**RE – Cookstown, Transitional Care Facility Reg Ref. SD22A/0361**

Please see following response from Áit U+L re: landscape related compliance items

DR-300 Further Information Clarification Submission April 2023

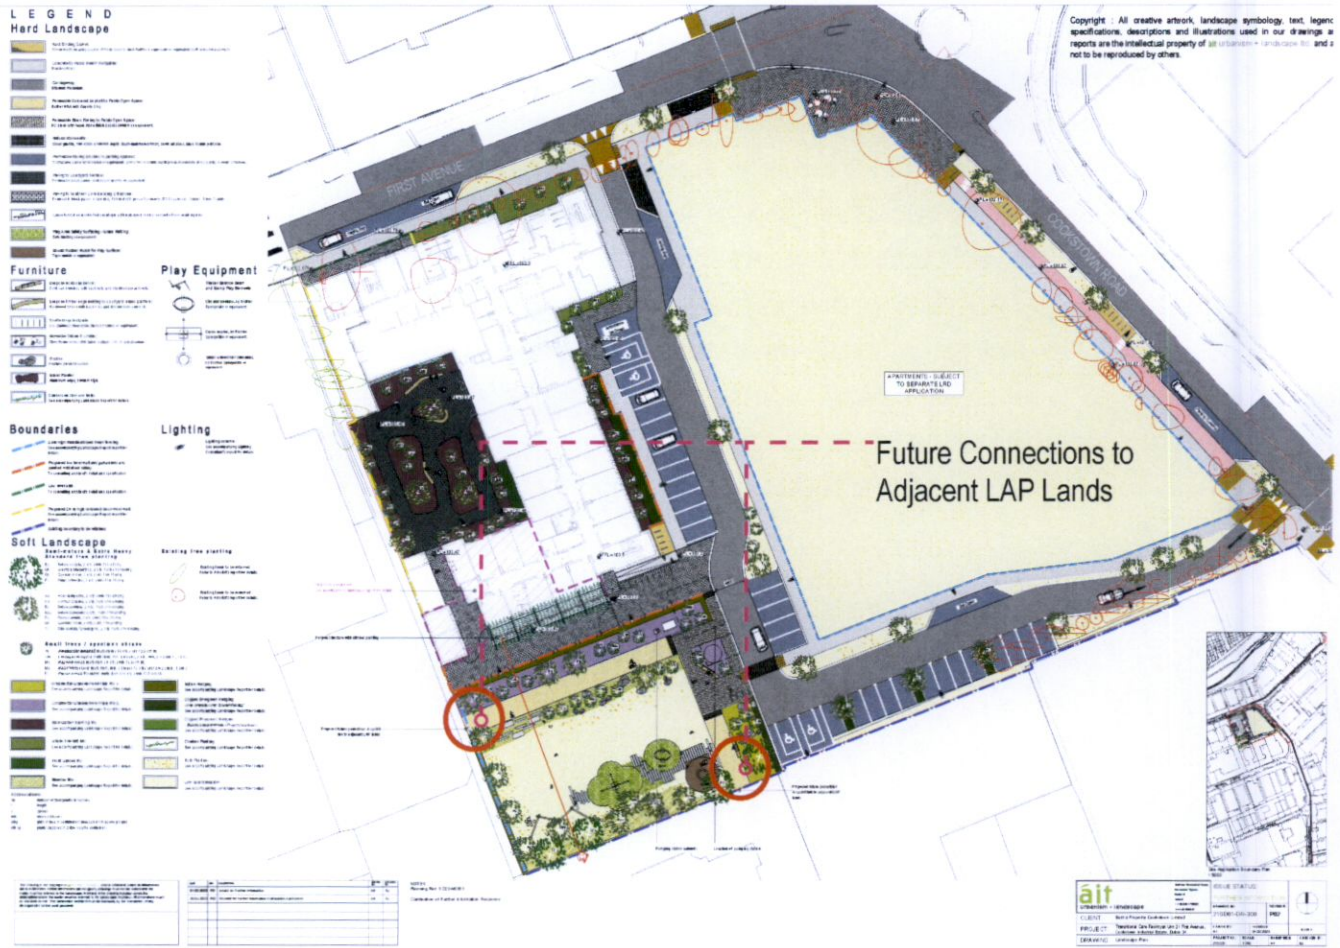
**Response to Item 2B *Pedestrian, Cyclist and Public Realm Upgrades:***

The plan for the site's proposed section of the pocket park has been revised to provide a high-quality shared pedestrian and cycle link to the adjoining lands to the south, via a connection in the parks' southeast corner. This new link will compliment the pedestrian & cyclist link already proposed east to west through the park to adjoining the LAP lands. contained within the resubmitted Landscape Report is a diagram detailing its connectivity to the wider adjoining LAP lands. The revised proposed POS plan also details additional, more varied play equipment to increase the play value of the site's portion of the wider Pocket Park. The proposed park's planting schedule contains a range of native and non-native tree, shrub & perennial planting with a mix of meadow and maintained lawn areas planted with seasonal bulbs to provide for pollinators and improve biodiversity. For further details please see 21SD01 DR-300, 21SD01 DR-301 & the accompanying resubmitted Landscape Report.

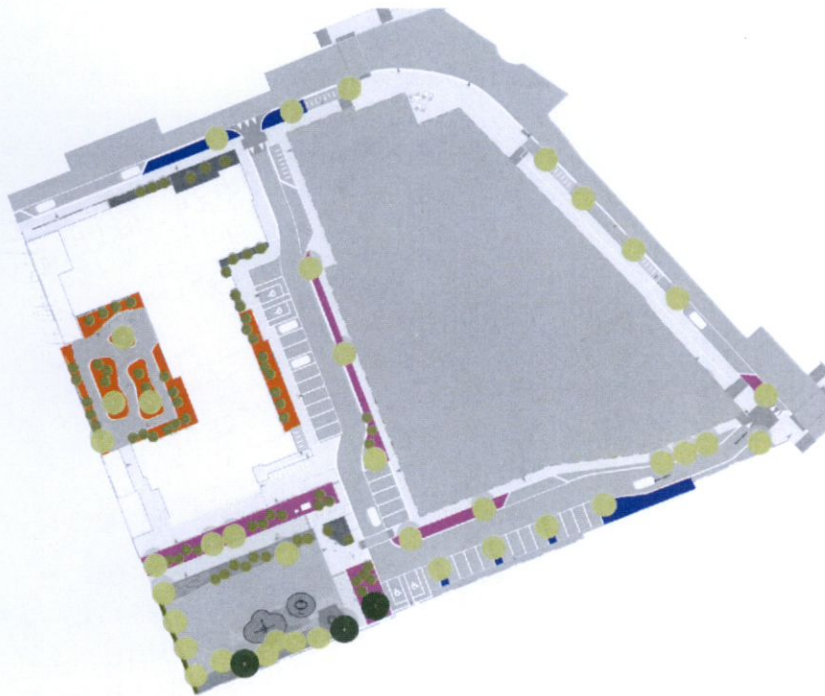
**Response to Item 4 Green Space Factor (GSF):**

As suggested in the received notification of 'Clarification of Additional Information' as consulting landscape architects, Áit U+L have engaged directly with SDCC's Public Realm Section. A Teams call meeting with Laurence Colleran from SDCC's Public Realm Section was held on Thursday April 13<sup>th</sup>. At the meeting it was discussed how the Green Factor Score may be improved for the Cookstown site and how mitigating measures could be implemented to supplement a failing score. Additional measures now proposed include a wider range of SuDS interventions across the site, including swales, stormwater tree pits and planted swale in combination with some 1300sqm of permeable paving surfaces. The additional measures have increased the Green Factor score for the site from 0.23 to 0.32, this score will still fall short of the required 0.5 for a REGEN site. To mitigate this short fall, additional habitat provision measures suggested at the engagement meeting are to be implemented. The measures include the installation of Bat Boxes within the park, installation of Swift boxes on the building façade and the installation of areas of sand at roof level, for creation of solitary bee habitat. For further details please see the accompanying resubmitted Landscape Report.
